The Commission has issued the enclosed Amendment Nos. 74 and 100 to Facility Operating License Nos. DPR-71 and DPR-62 for the Brunswick Steam Electric Plant, Units 1 and 2. The amendments consist of changes to the Technical Specifications in response to your submittal of May 7, 1984.

The proposed amendments would revise Section 3/4.7.5 of the Technical Specifications to eliminate Table 3.7.5-1 (Safety-Related Hydraulic Snubbers) and conform with guidance provided by the Commission in its letter dated May 3, 1984 (Generic Letter No. 84-13) and to incorporate miscellaneous administrative changes to Sections 3/4.7.6 and 3/4.7.7.

Amendment No. 74
License No. DPR-71

SAFETY EVALUATION BY THE OFFICE OF NUCLEAR REACTOR REGULATION
SUPPORTING AMENDMENT NO. 74 TO FACILITY LICENSE NO. DPR-71 AND
AMENDMENT NO. 100 TO FACILITY LICENSE NO. DPR-62
CAROLINA POWER & LIGHT COMPANY
BRUNSWICK STEAM ELECTRIC PLANT, UNITS 1 AND 2
DOCKET NOS. 50-325 AND 50-324

Figure 4.7.5-1

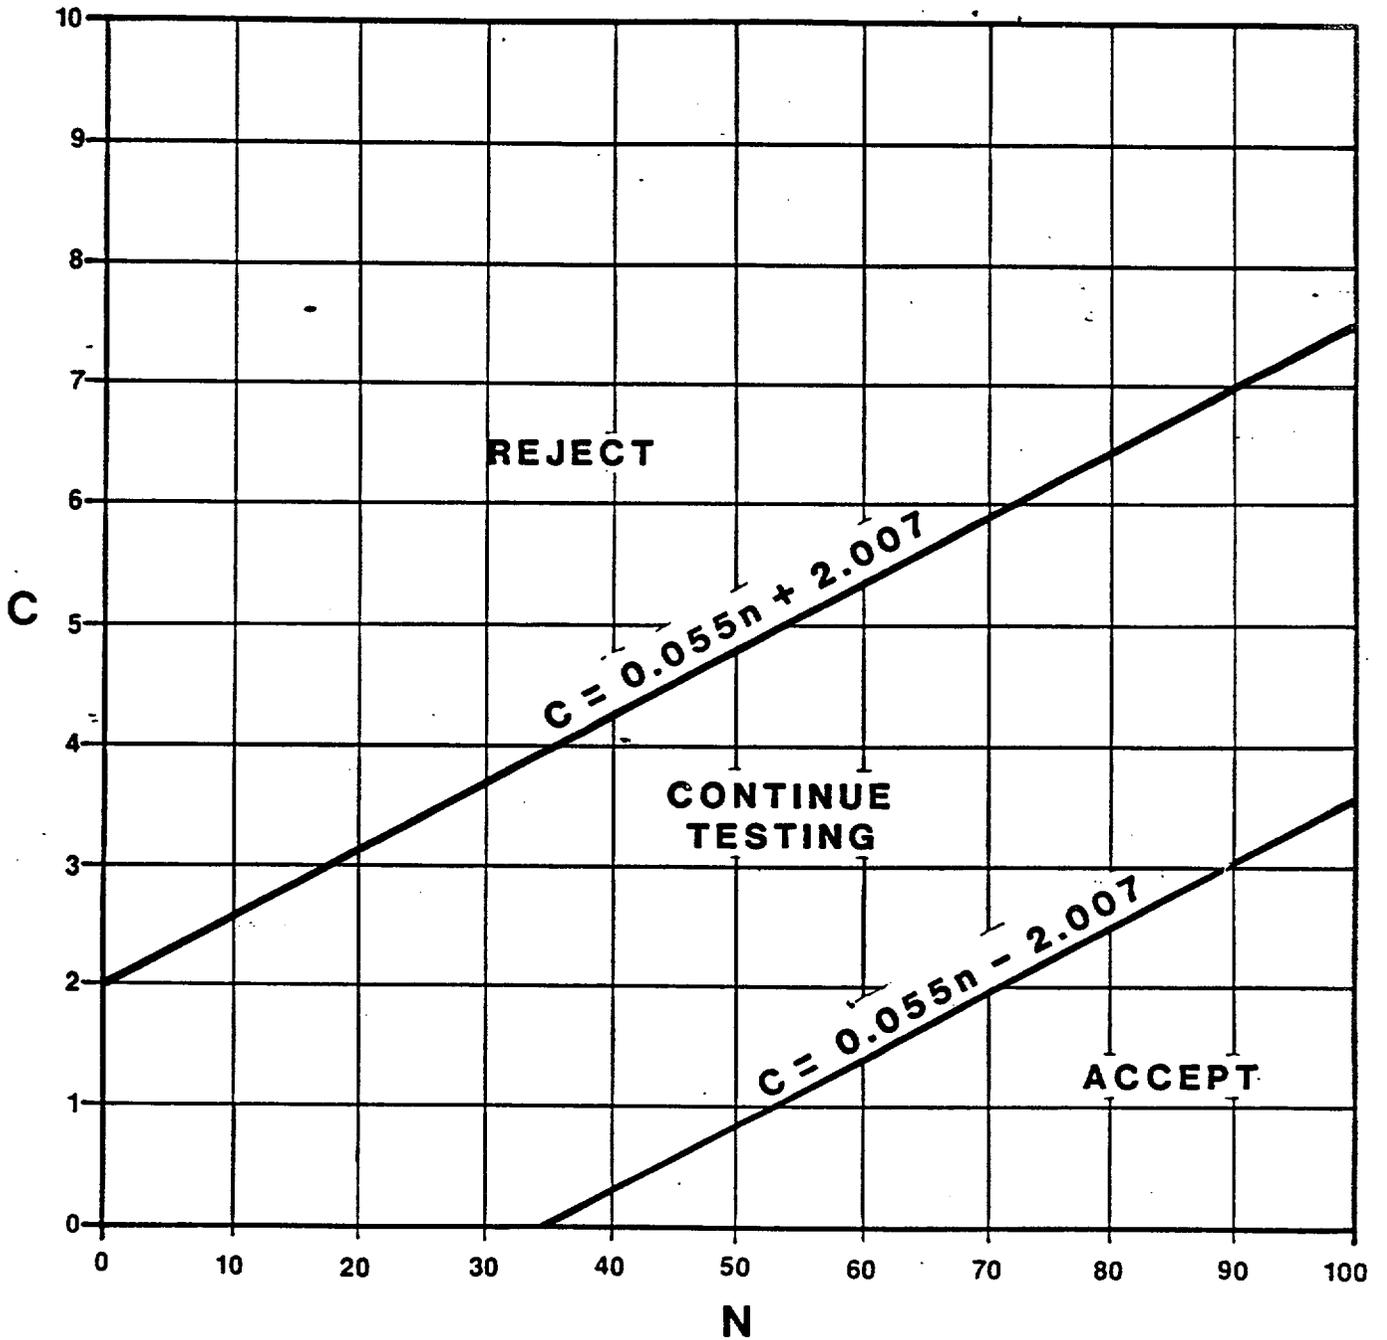
- 2) A representative sample of each type of snubber shall be functionally tested in accordance with Figure 4.7.5-1. "C" is the total number of snubbers of a type found not meeting the acceptance requirements of Specification 4.7.5.f. The cumulative number of snubbers of a type tested is denoted by "N." At the end of each day's testing, the new values of "N" and "C" (previous day's total plus current day's increments) shall be plotted on Figure 4.7.5-1. If at any time the point plotted falls in the "Reject" region all snubbers of that type shall be functionally tested. If at any time the point plotted falls in the "Accept" region, testing of snubbers of that type may be terminated. When the point plotted lies in the "Continue Testing" region, additional snubbers of that type shall be tested until the point falls in the "Accept" region or the "Reject" region, or all the snubbers of that type have been tested. Testing equipment failure during functional testing may invalidate that day's testing and allow that day's testing to resume anew at a later time, providing all snubbers tested with the failed equipment during a day of equipment failure are retested.

Figure 4.7.5-1

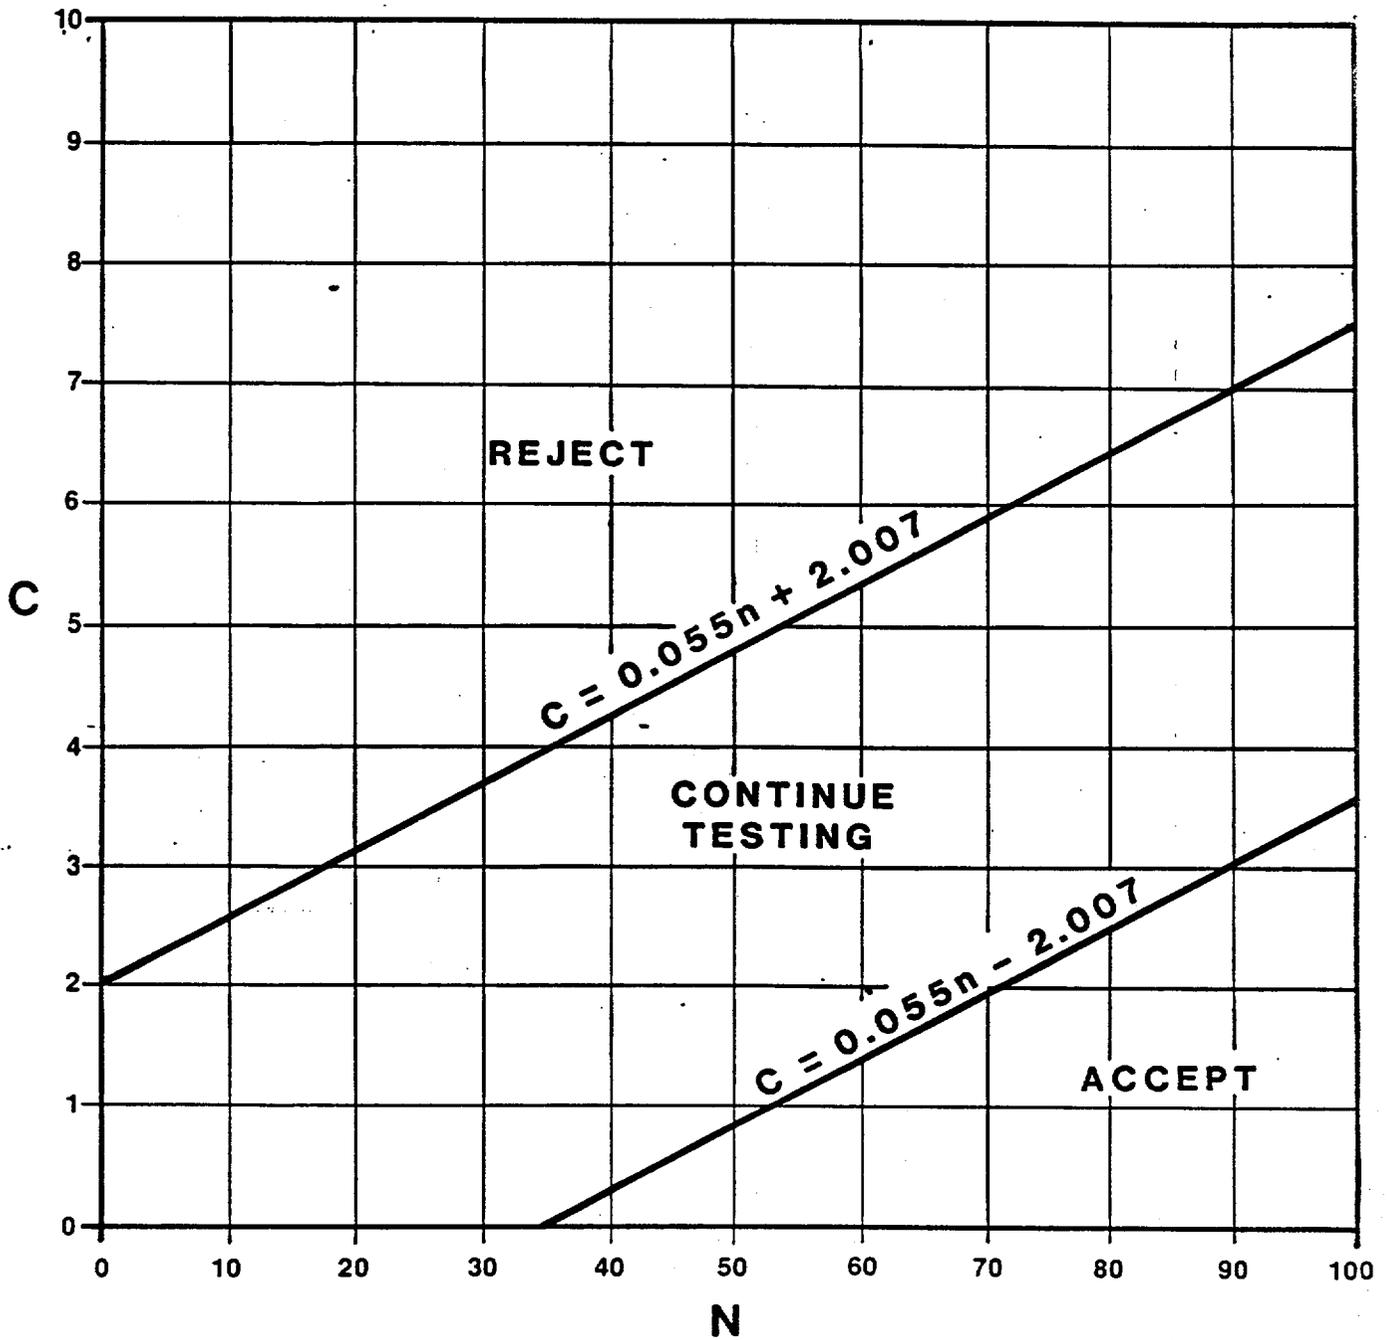
- 2) A representative sample of each type of snubber shall be functionally tested in accordance with Figure 4.7.5-1. "C" is the total number of snubbers of a type found not meeting the acceptance requirements of Specification 4.7.5.f. The cumulative number of snubbers of a type tested is denoted by "N." At the end of each day's testing, the new values of "N" and "C" (previous day's total plus current day's increments) shall be plotted on Figure 4.7.5-1. If at any time the point plotted falls in the "Reject" region all snubbers of that type shall be functionally tested. If at any time the point plotted falls in the "Accept" region, testing of snubbers of that type may be terminated. When the point plotted lies in the "Continue Testing" region, additional snubbers of that type shall be tested until the point falls in the "Accept" region or the "Reject" region, or all the snubbers of that type have been tested. Testing equipment failure during functional testing may invalidate that day's testing and allow that day's testing to resume anew at a later time, providing all snubbers tested with the failed equipment during a day of equipment failure are retested.
